PLANNING COMMITTEE

Meeting of the Planning Committee – 08th December 2020

Item 5 – 19/01263/MFULE - Land Adj to River Foss, Lilling Low Lane, West Lilling

River Foss Flood Storage Area Planning Application

Figure 5: 1 in 100yr plus climate change (winter storm, 47hr critical storm duration) and ALC grades

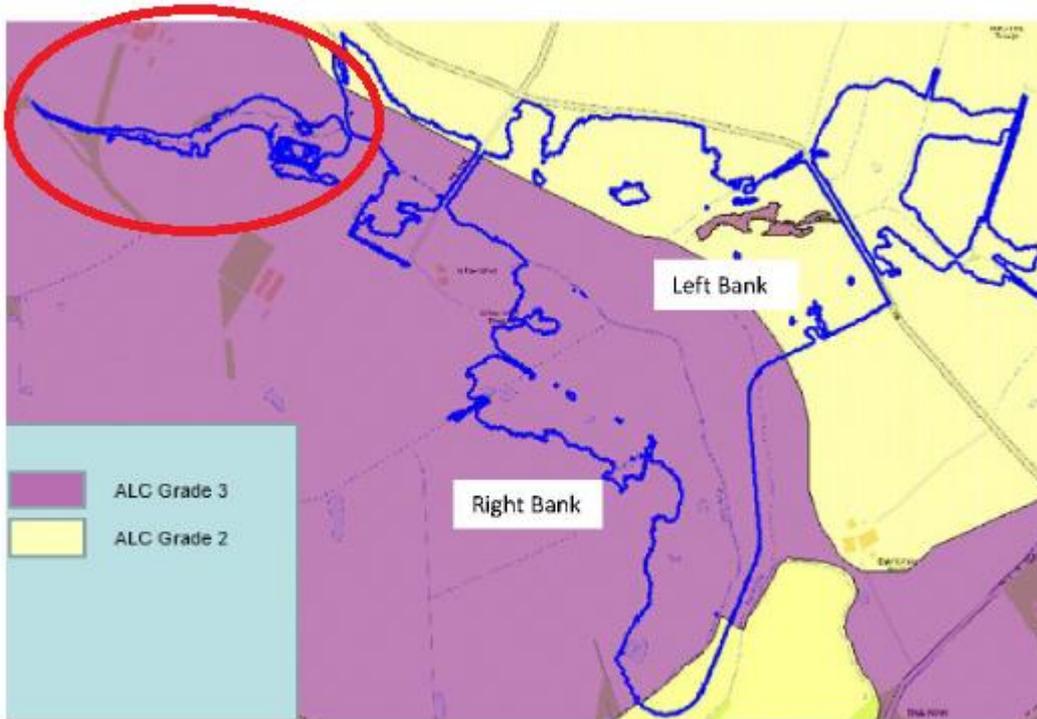
1. Red Line Boundary – The Wadsworth Family raised concern (Doc. No. 2111363) that some of the flood risk area of the scheme falls outside the current red line boundary. The applicant responded (Doc. No. 2114409) stating that the area already floods, the area has been modelled, and is not at risk from the FAS scheme. We feel that this needs further consideration – specifically that the flooding on Eel Hole Dyke and Anchor Plain Dyke are not increased by the scheme (please also note the Point 2 below and the comments made in the attached report).
 - Report 2076068 '*Supplementary Statement River Foss Flood Storage Area Planning Application Applicant's Responses to Natural England Updated Representations*' – Figure 5 (1 in 100yrs plus climate change (winter storm, 47hr critical storm duration) and ALC grade):
